ADDENDUM No. 1

ITB No. 4685

2021 SIDEWALK GAP ELIMINATION

CITY OF ANN ARBOR - PUBLIC SERVICES - ENGINEERING
SCALE
DRAWING No. 2021007-1
SHEET No. 1 OF 29

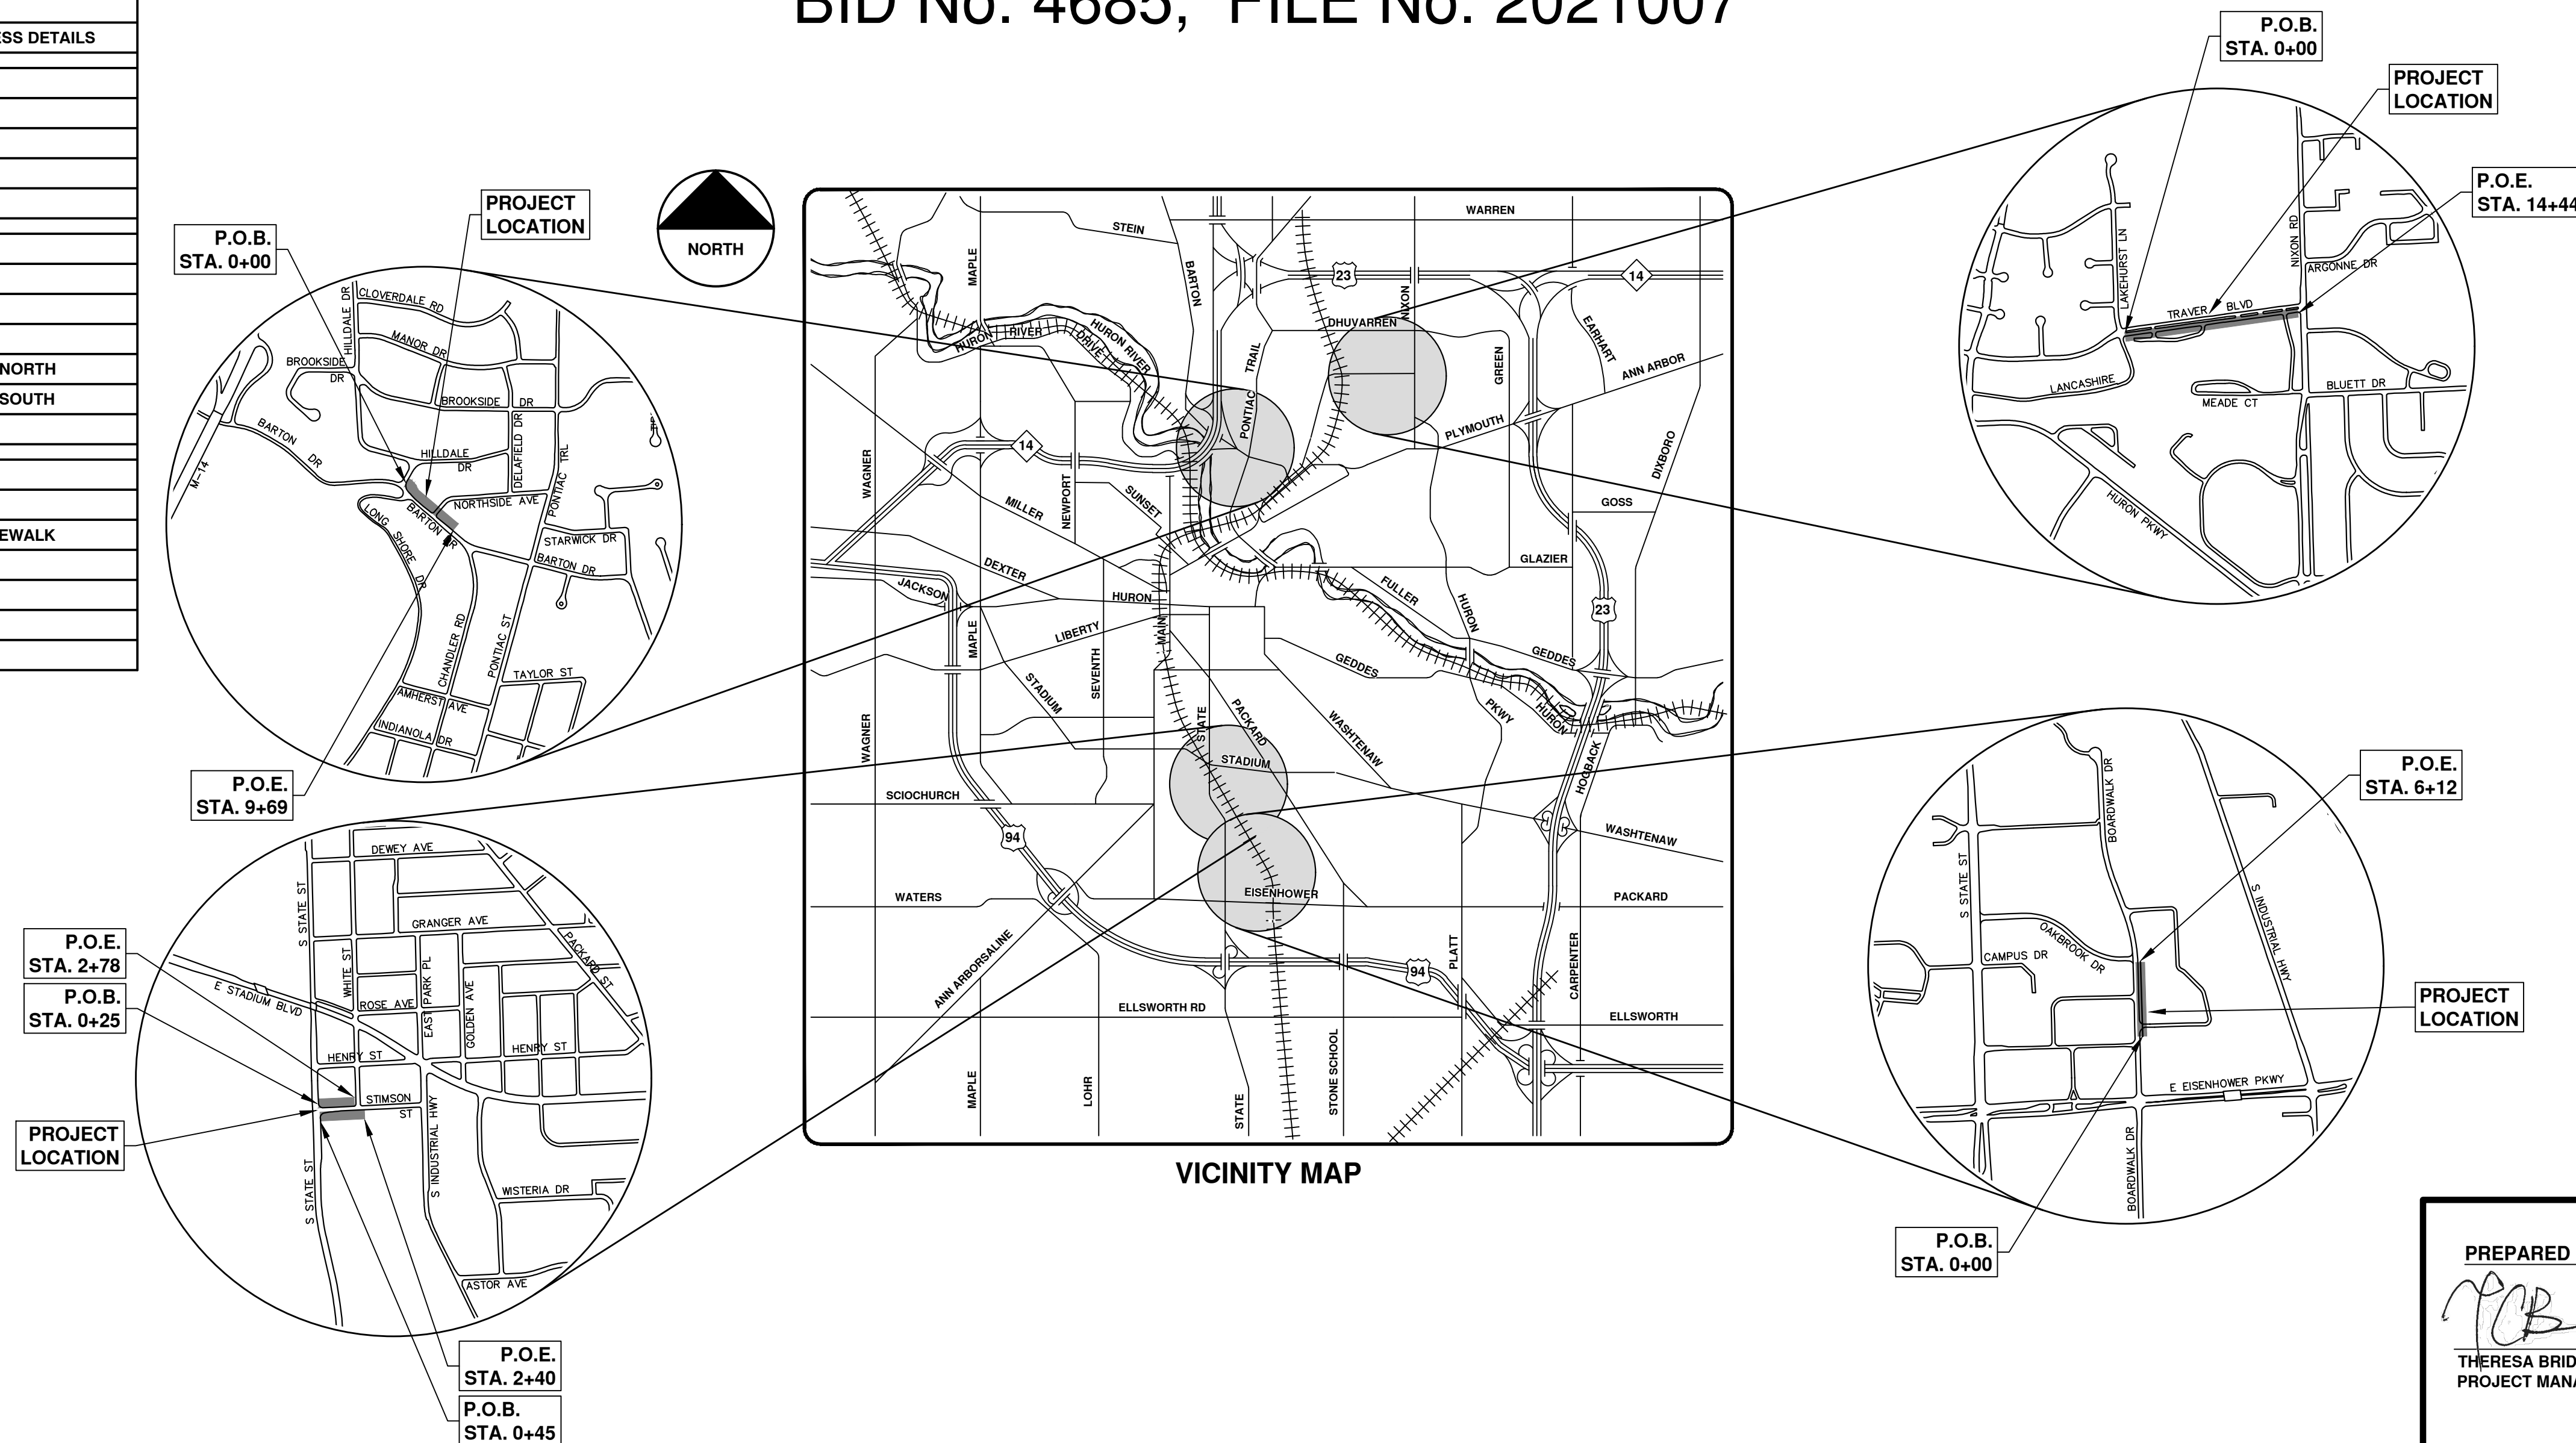
Drawings/1	Revised Sheet List Table.
Drawings/2	Revised Construction Notes 7-9, 12, 14.
Drawings/11	Revised sidewalk type on the southwest corner of Barton and Northside.
Drawings/11-13	Profile grade labels indicate location south face of walk.
Drawings/17	Extended lane closure on north side; indicated temporary pavement markings; added pedestrian routing.
Drawings/18-19	Reduced removal and replacement limits on south side at east and west ends; added temporary grading easement.
Drawings/20-21	Added profile information.
Drawings/23	Removed barricades at southerly most driveway
Drawings/24	Revised sidewalk type through driveways to eliminate fibermesh
Drawings/25	Added pedestrian routing; reduced scope of MOT, eliminating north side of Traver and corners of Traver and Lakehurst/Lancashire intersection.
Drawings/26-29	Eliminated removal and replacement in median, at north side of Traver, and at all corners of Traver and Lakehurst/Lancashire intersection; eliminated extension of median at east leg of Traver and Lakehurst intersection.
